Access Compliance Report

Public Rights-of-Way

(Curb Ramps)

Intersection ID: 52081	Main Street: LAWYERS_RD	Cross Street: E_W_T_HARRIS_BV	Location: SE
ADA ID: 3FD6E8016BBB	Ramp Type: Perp	Initial Pass/Fail: Fail	Overall Compliance: No
Severity Score: 10			
Codes/Mitigation Info/Possible Solution		Field Measurements/Component Compliance

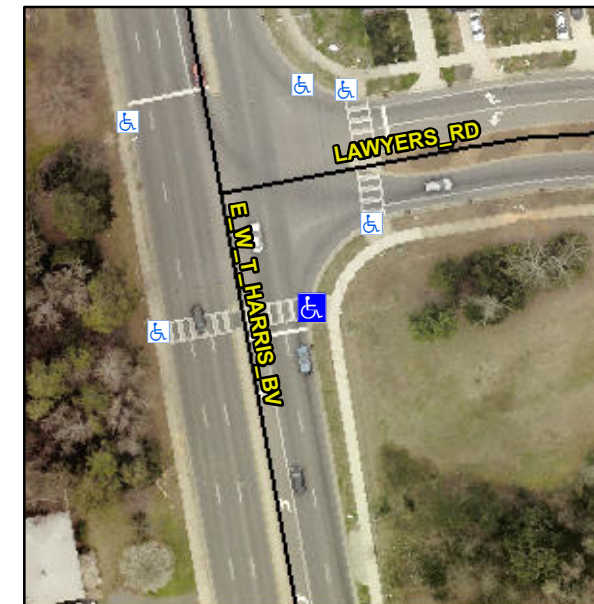
Not Found, R304.5.1, R304.5.3

Compliance	Description	Data	Compliance	Description	Data
N/A	Ramp Length (in)	96.0	Yes	Ramp Slope (%)	8.1
No	Ramp Width (in)	47.5	No	Ramp XSlope (%)	2.7
N/A	Flare Type LT	N/A	N/A	Flare Type RT	N/A
N/A	Flare Slope LT (%)	N/A	N/A	Flare Slope RT (%)	N/A
N/A	Flare Traversable LT?	N/A	N/A	Flare Traversable RT?	N/A
N/A	Landing Length (in)	N/A	N/A	DWS Provided?	N/A
N/A	Landing Width (in)	N/A	N/A	DWS Contrast?	N/A
N/A	Landing Slope (%)	N/A	N/A	DWS Length (in)	N/A
N/A	Landing X Slope (%)	N/A	N/A	DWS Full Width?	N/A
N/A	Landing Curb? (Y/N)	N/A	N/A	DWS Offset (in)	N/A
N/A	Shared Landing?	N/A			
N/A	Gutter Ponding?	N/A	N/A	Gutter Slope (%)	N/A
N/A	Gutter Lip Ht (in)	N/A	N/A	Gutter X Slope (%)	N/A
N/A	Painted X Walk1?	Yes	N/A	Painted X Walk2?	N/A
	X Walk 1 Direction	To W		X Walk 2 Direction	N/A
N/A	X Walk 1 Width (in)	115.0	N/A	X Walk 2 Width (in)	N/A
	X Walk 1 Slope (%)	0.6		X Walk 2 Slope (%)	N/A
	X Walk 1 X Slope (%)	1.3		X Walk 2 X Slope (%)	N/A

Remove & Replace Entire Ramp.
